**Municipal Services Center, Council Chamber
3600 Tremont Road**

Subject: 2395 Andover Road (VAR-16-24) - To allow a two-story addition to project up to 16'-10" into the rear yard profile, continuing the existing ridge.

Subject: 2571 Clarion Court (VAR-19-24) - To allow a detached garage that is 21'-6" in height, when 17 feet is the limit.

LINE OF SIGHT ELEV.		
Project number	Project Number	DTL-1
Date	4-2-24	
Drawn by	Author	
Checked by	Checker	
		Scale 1/8" = 1'-0"

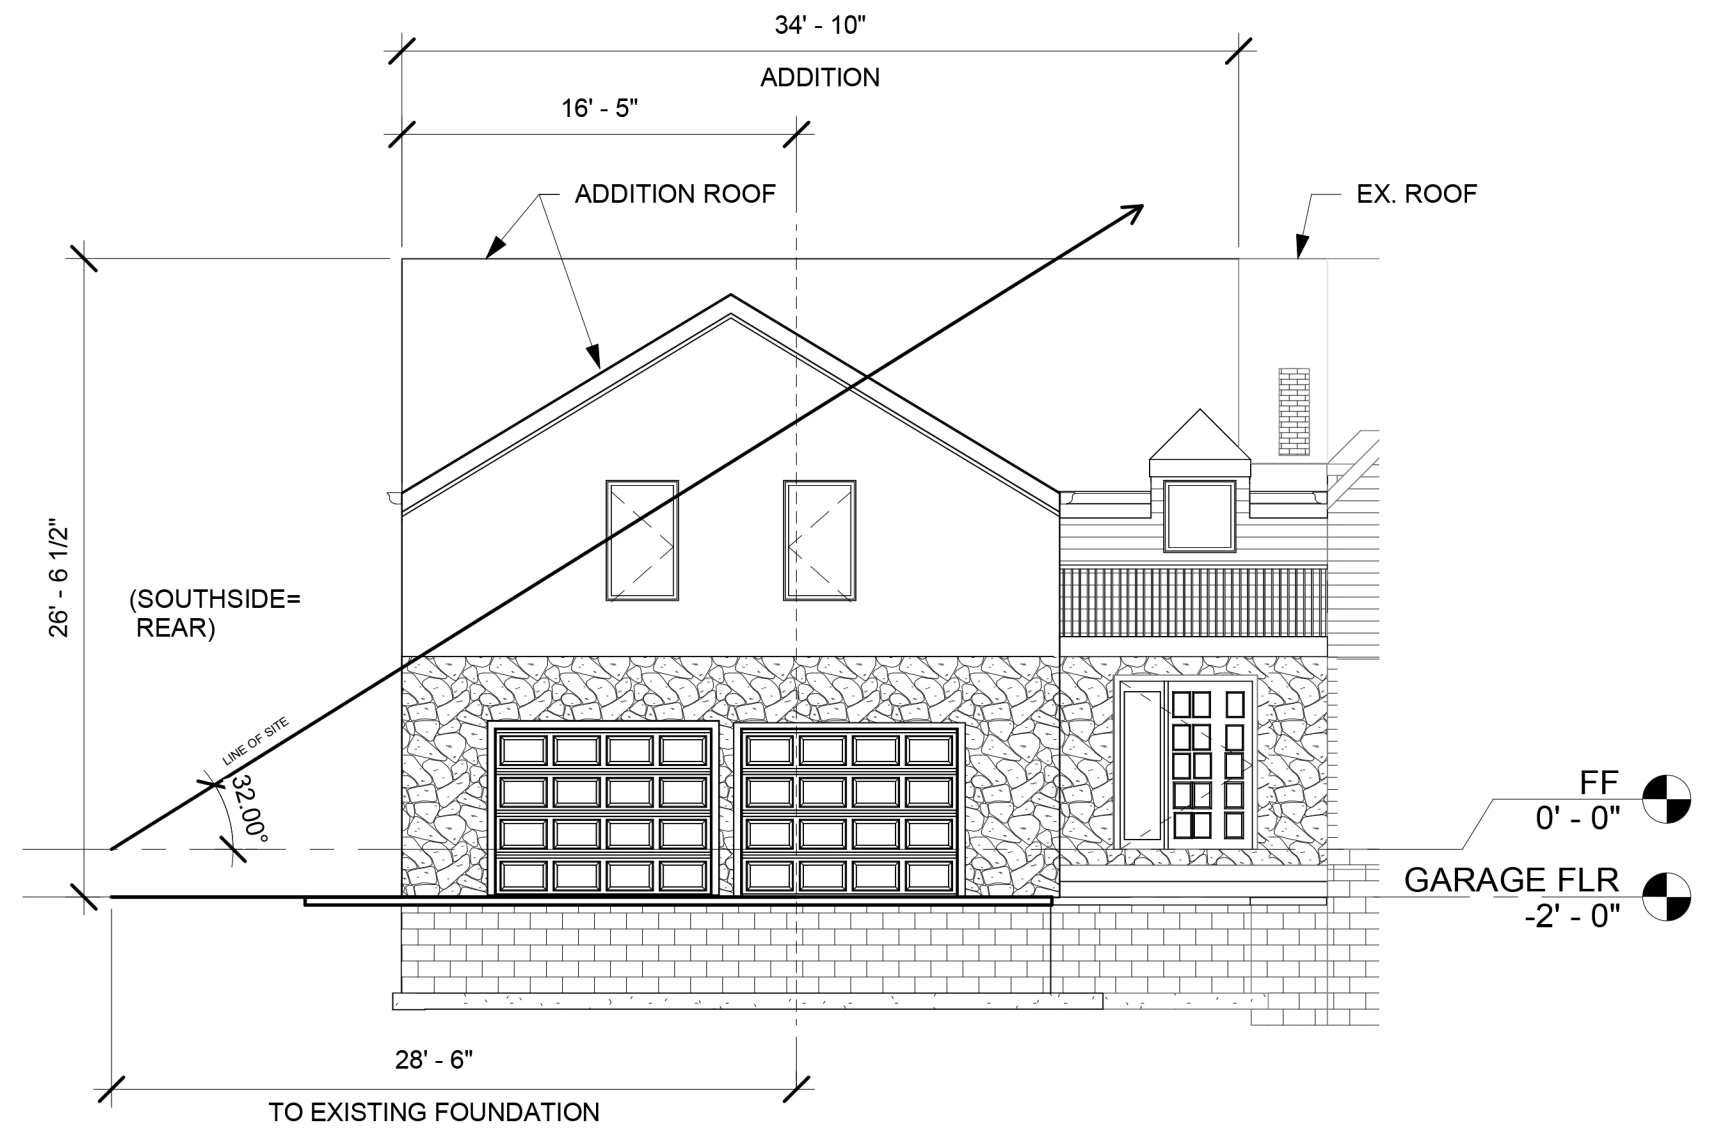
The rear yard profile is an angle measured from the rear property line, back toward the house, that the ridge has to stay beneath. This is established to limit looming effects on rear yard neighbors. Staff would add that the forward-facing gable projects 7'-2" into the rear yard profile.

In response to the postponement of this application at the April 17, 2024 BZAP hearing, the applicant tried to address concerns raised by the Board and have submitted revised plans. The two gables and overall heights remain unchanged, meaning the projections into the rear yard profile are unchanged. The applicant has, however, revised the proposed south elevation so that it will match the north elevation. Window types and sizes on the two-story addition have also been adjusted to better match the existing residence. In the revised plans, the applicant noted that they've explored alternate options to reduce the height of the addition, but do not have a solution that retains the same programming and complimentary architecture.

A301

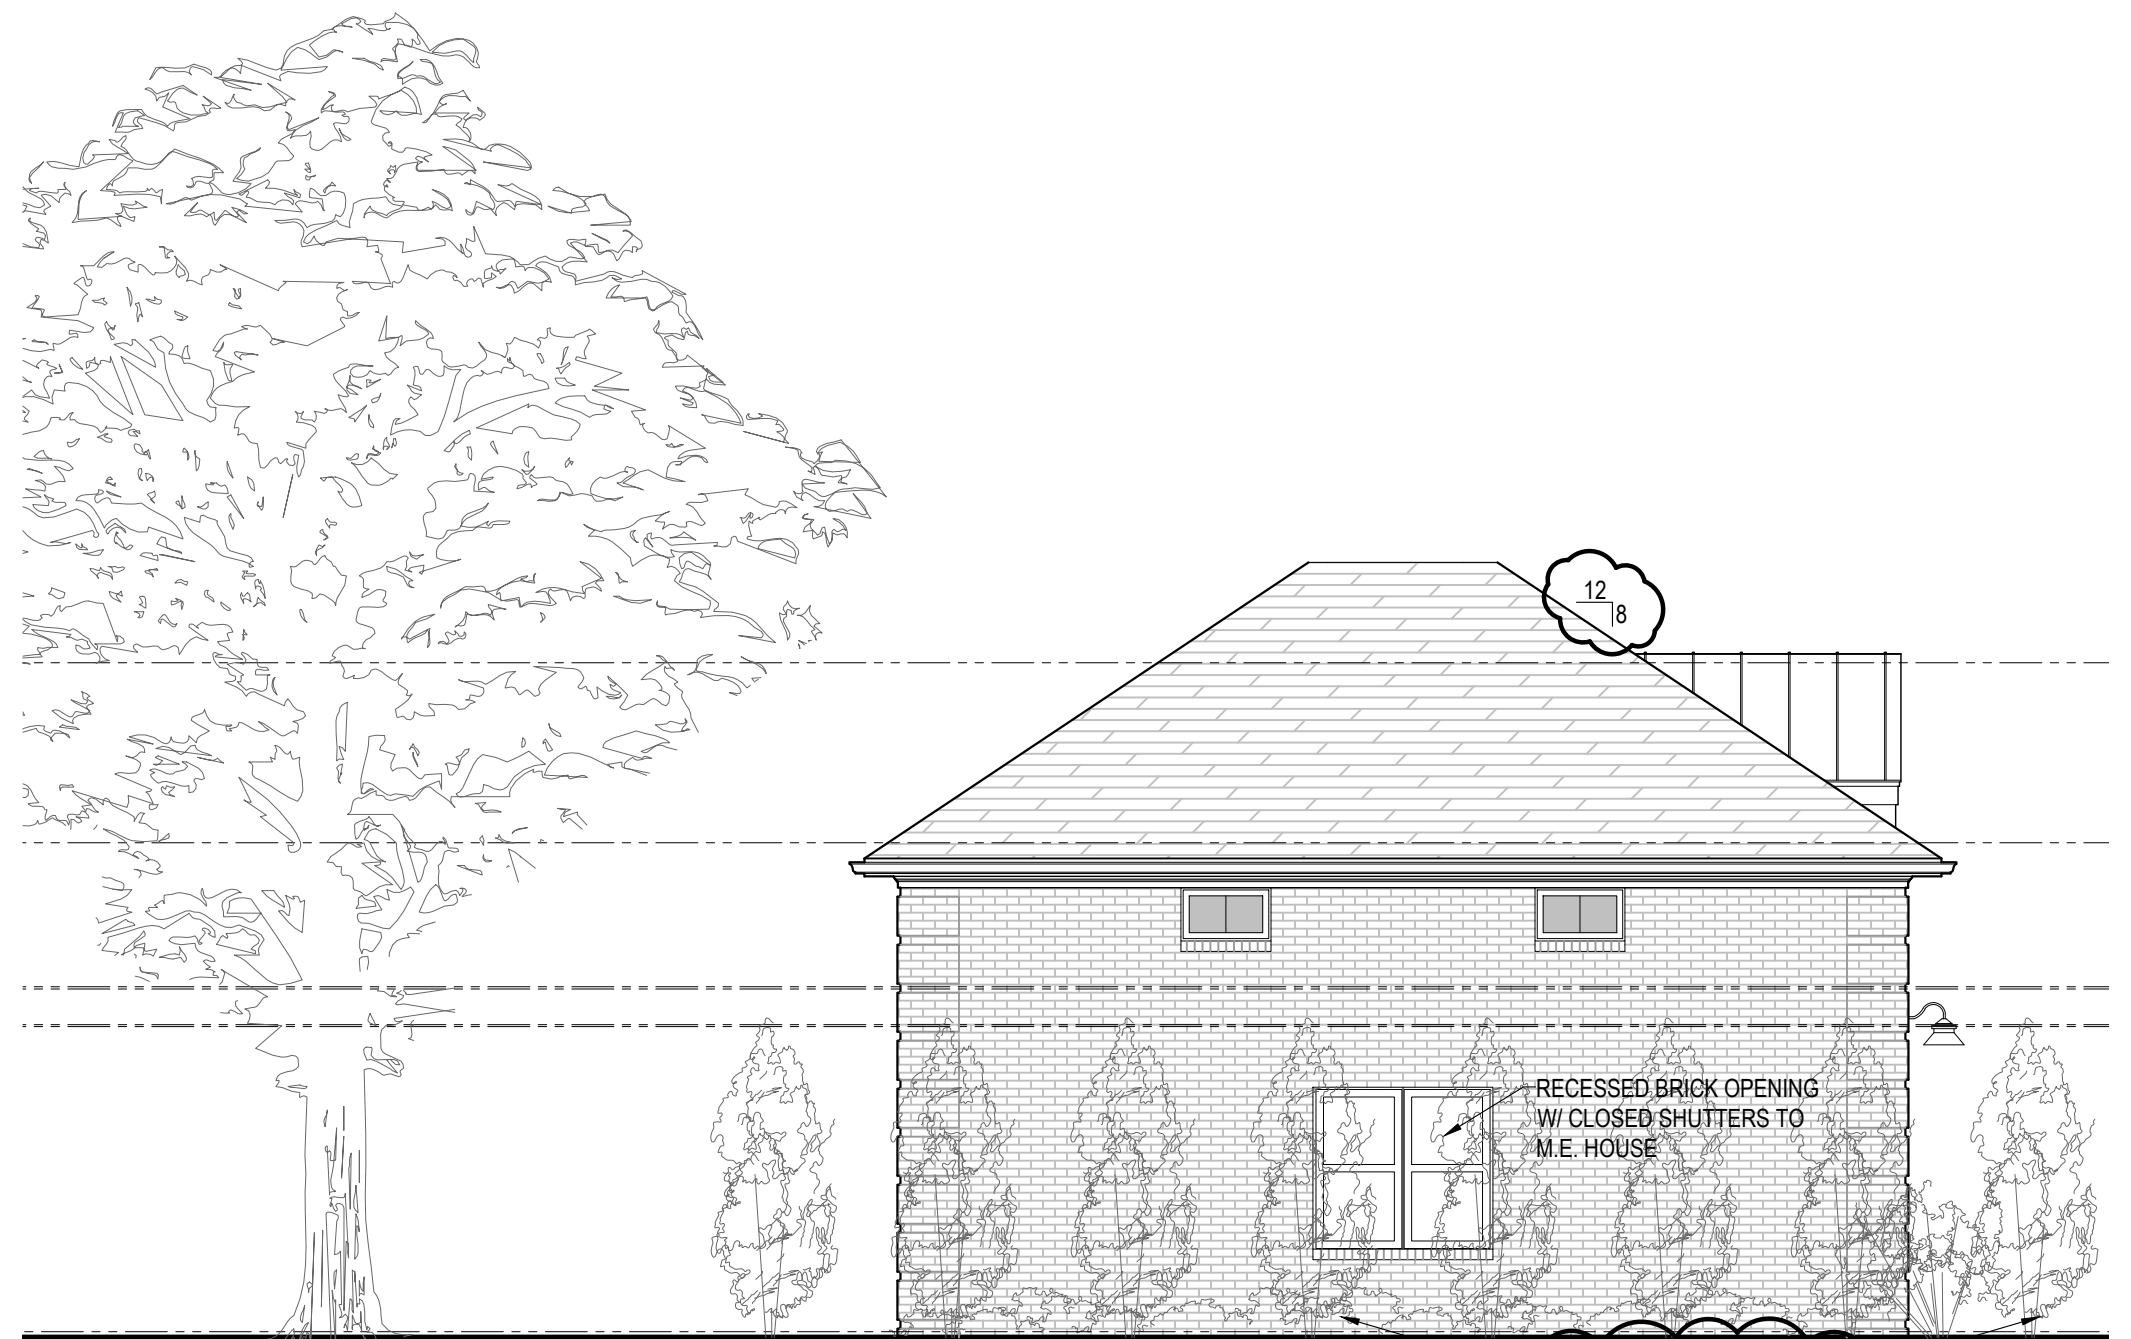
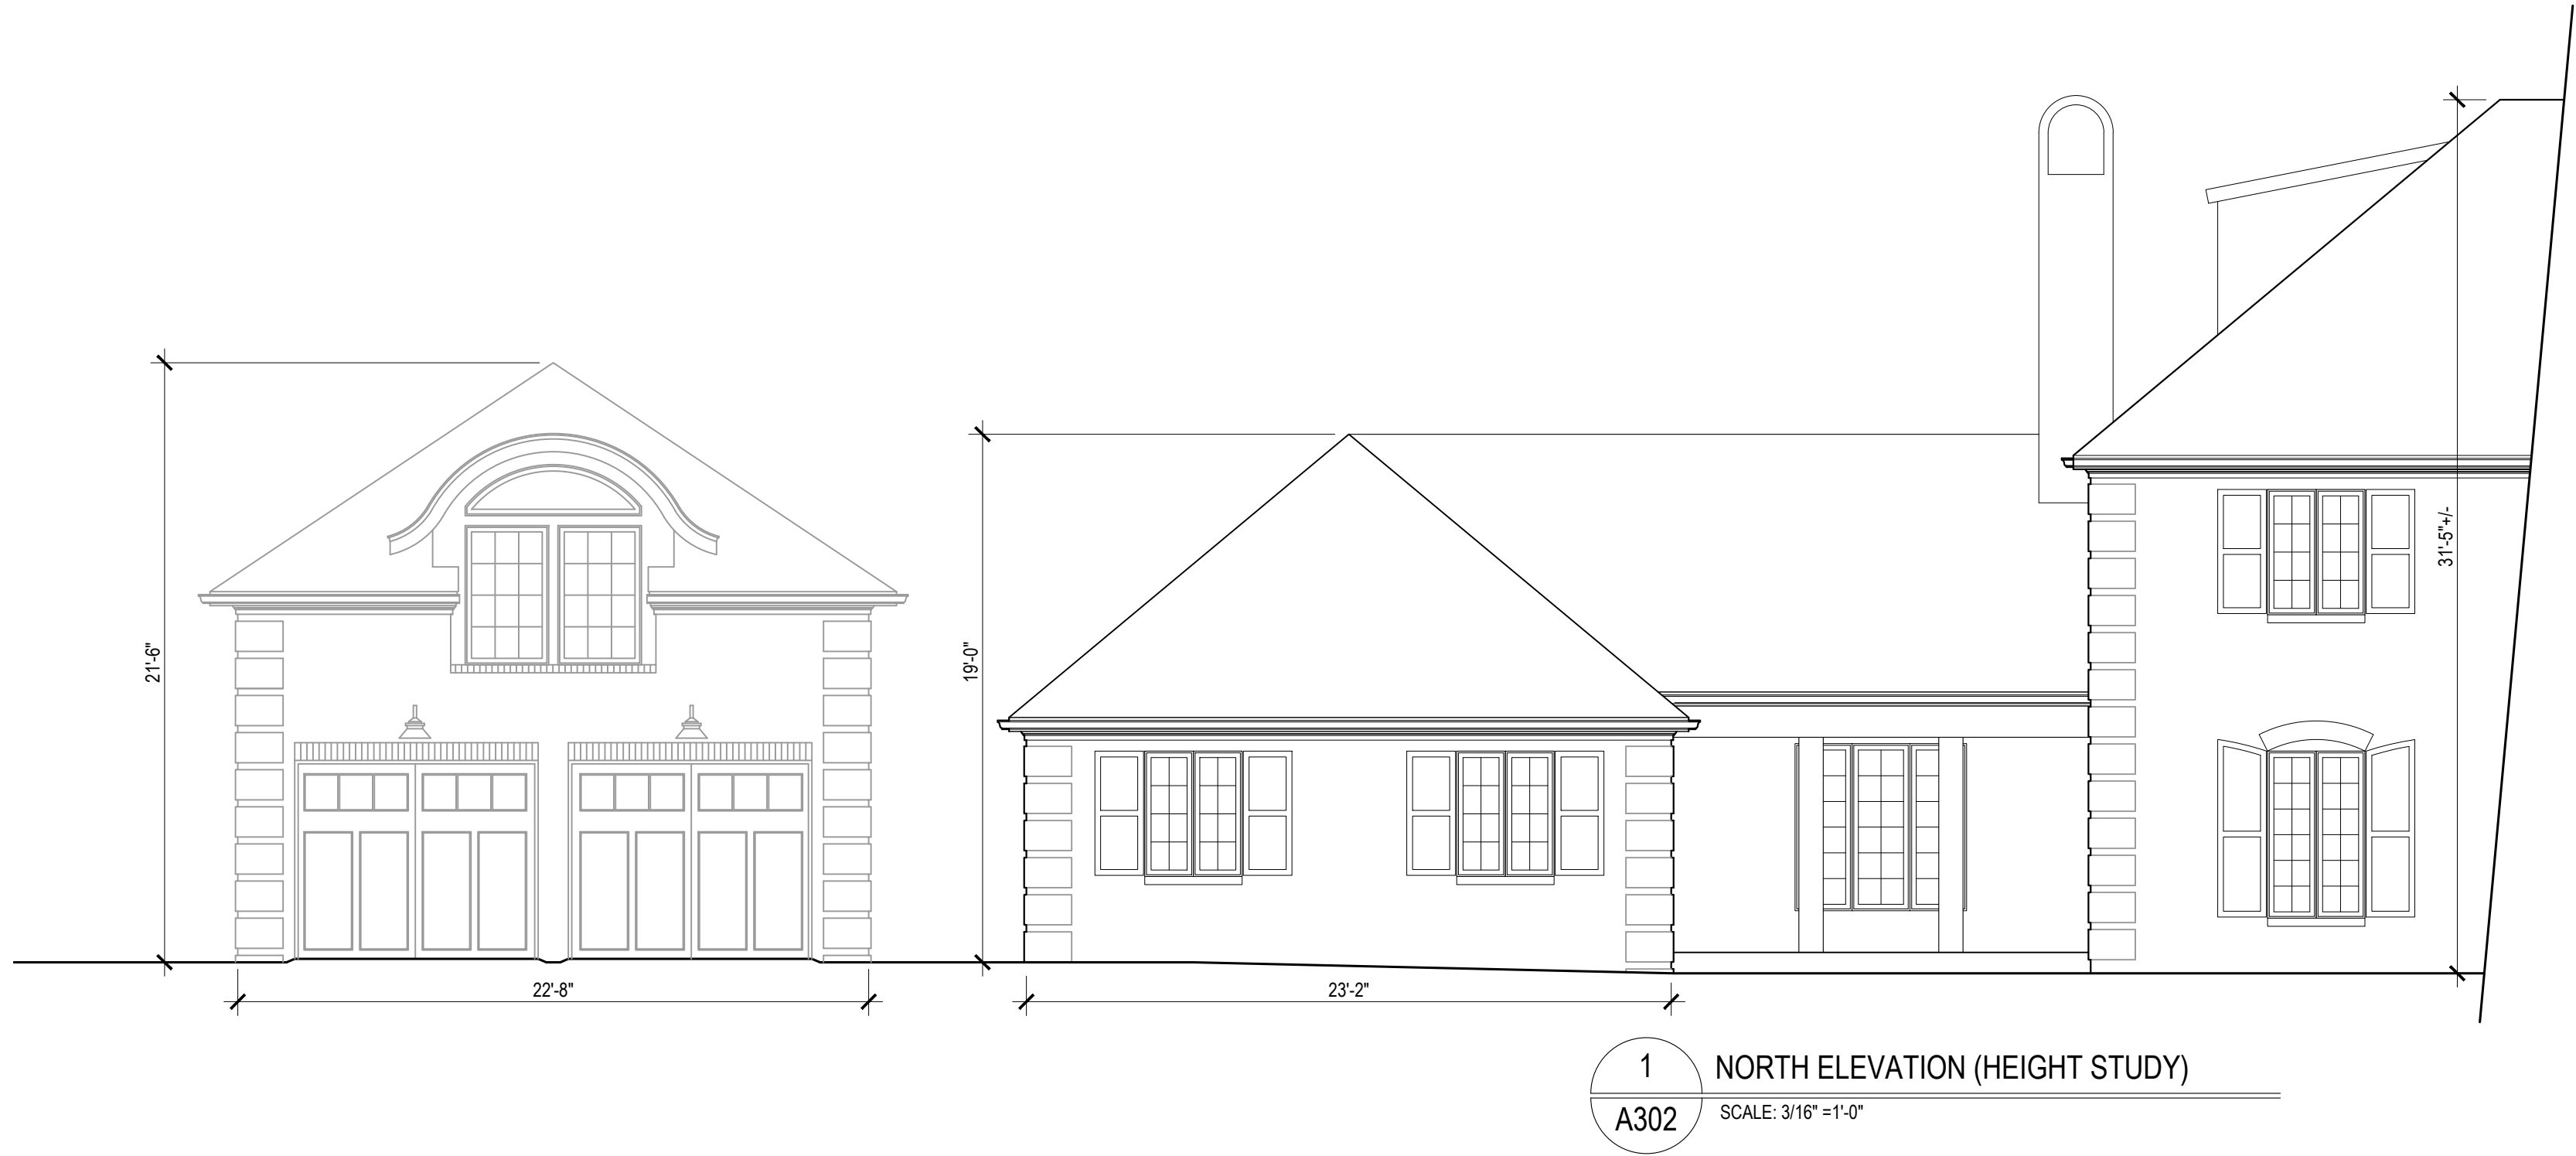
The applicant will be present to share revised plans for a detached garage with a second floor office space. At the April 17th meeting, the Board shared concerns about the height of the proposed garage being located so close to the side property line. The Board also recommended reducing the size of the front window, adding landscaping to help screen the garage from neighboring properties, and pushing the garage farther back from the street. There was also concern about the garage being taller than the nearest roofline on the home and not having a complimentary scale/massing as the home.

The applicant has addressed many of these concerns including reducing the height of the garage from 25'-9" to 21'-6" (4'-3" reduction), reducing the size of the front window, and adding Emerald Petite arborvitae along the side property line for screening. The applicant also looked at relocating the garage farther from the street but found this could potentially impact the large tree in the rear yard, and it was not the preferred location for the homeowner.
